Figure 9. Massing model with annotations

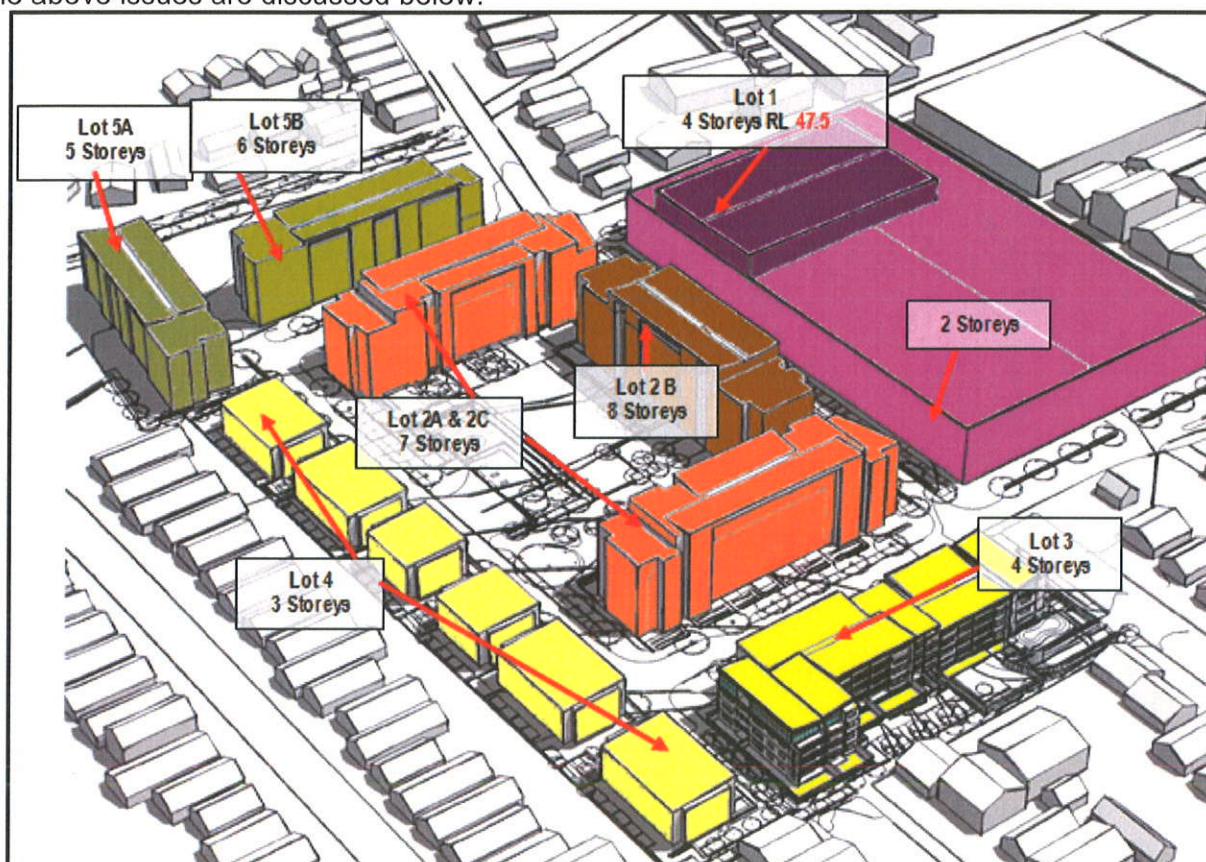
The Department does however raise concerns with particular aspects of the proposed height and built form including:

- the height, building separation and articulation of the residential development on Lot 2;
- the height, access and usability of the open space podium; and
- the height of the seniors living building known as 5A.

Figure 10. Open Space – Levels

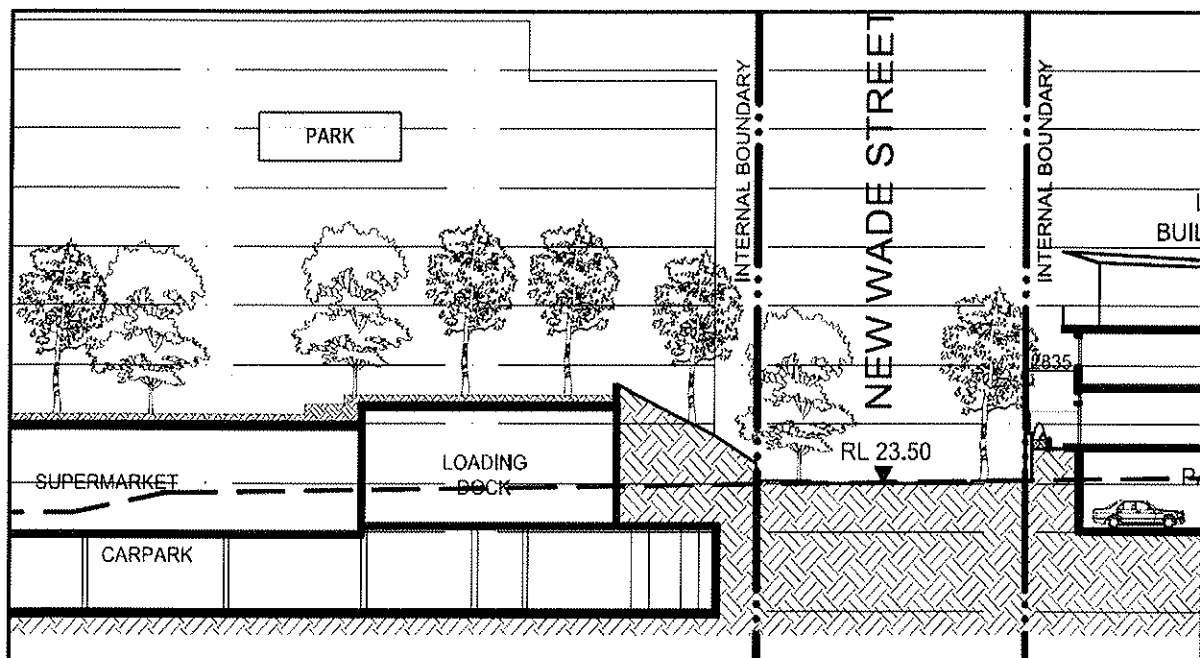
Concern is also raised regarding the useability and accessibility of the proposed public open space on Lot 2. The park sits on a podium above a proposed supermarket, car park and loading dock and is surrounded by residential development to the North South and West. The main access to the park is from New Wade Street, however, the difference in levels between the street and the open space at its highest point is over 5m is unresolved. The park should be easily read as an open space area from the surrounding public domain and easily accessible to the public. The car park, loading dock and supermarket underneath the park dictate the height of the open space podium, which can be seen below in **Figure 10**.

It is considered that the accessibility of the park is an issue which will require further resolution at future detailed design stage therefore no approval is granted for the height of the open space podium. To ensure this issue is resolved a modification is proposed on the Concept Plan approval requiring the submission of further design details to ensure the public open space corresponds to the public domain (particularly along New Wade Street) and is easily accessible without the need for steep changes in gradient.

Figure 11. Section plan for residential building - Lot 3

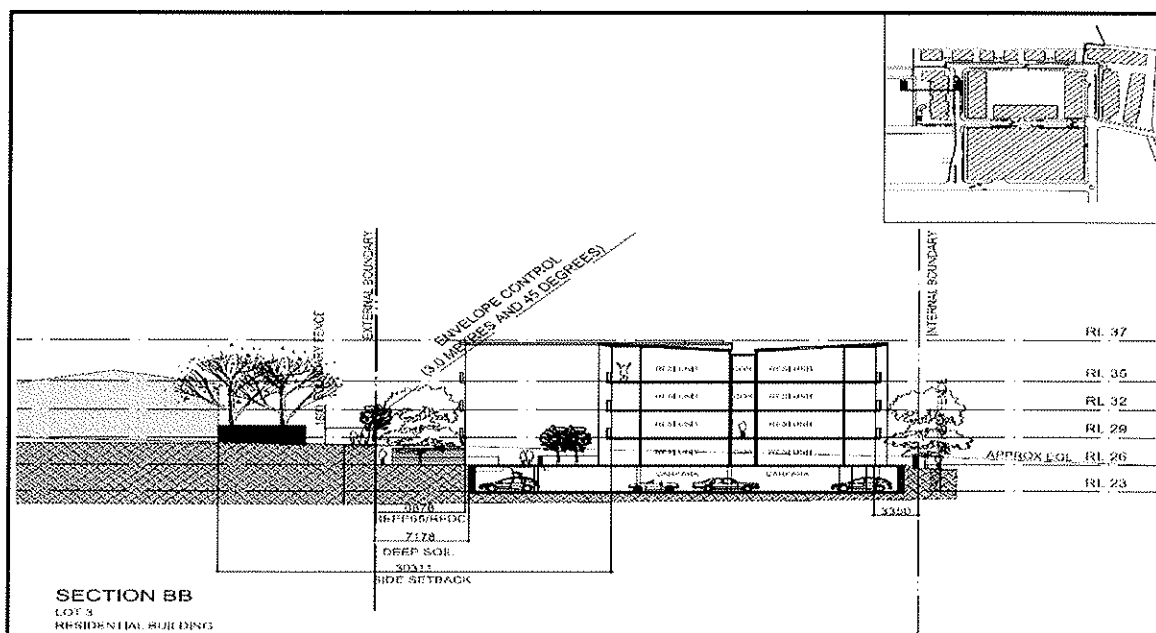
The height, bulk and scale of the proposed 4 storey residential flat building on lot 3 is considered to be acceptable. The proposed building provides an appropriate transition in height from the surrounding 1-2 storey development to the north of the site. Much of the northern boundary has been cut to a depth of approximately 1 storey (see **Figure 11**) which further reduces the height and visual impact of this building. The proposed materials, finishes and building projections are considered to be acceptable and provides sufficient visual interest and building articulation. The proposal has also been assessed against SEPP 65 and the RFDC (**Appendix E**) and is considered satisfactory despite some minor non compliances. The Department considers that the built form as proposed provides an appropriate design solution which is sympathetic and respectful to the scale of the adjoining buildings and responds to the constraints and opportunities associated with the site.
